Product Change Notification

113205 - 00

Change Notification #: 113205 - 00
Change Title: Intel® Server System R2312GZ4GC4
PCN 113205-00, Product Design
Update Resistors and Capacitors
Date of Publication: August 13, 2014

Figure 1. Component Locations for the 2U Riser Spare A2UL8RISER

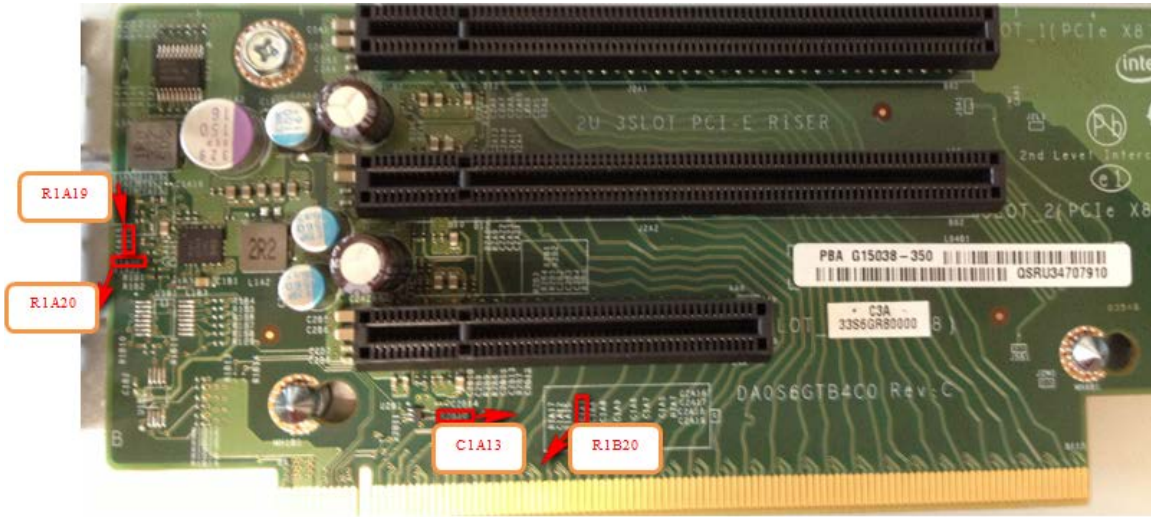
Update the following resistors and capacitor (see Table 1 and Figure 1) on the 2U PCIe Riser Spare A2UL8RISER to make an improvement to support a higher 3.3 Voltage Regulator startup over current. Before this change, the Voltage Regulator on the riser card may not be able to turn on when the total current drawn is more than 5A current. After this change, the Voltage Regulator on the riser card can support more than 10A current.

Component	Location	Pre-change	Post-change
Resistor	R2B10	10.0 kOhm	3.65 kOhm
Resistor	R1A20	0 Ohm	30 Ohm
Resistor	R1A19	40.2 kOhm	20 kOhm
Capacitor	C1A13	10 pF	120 pF
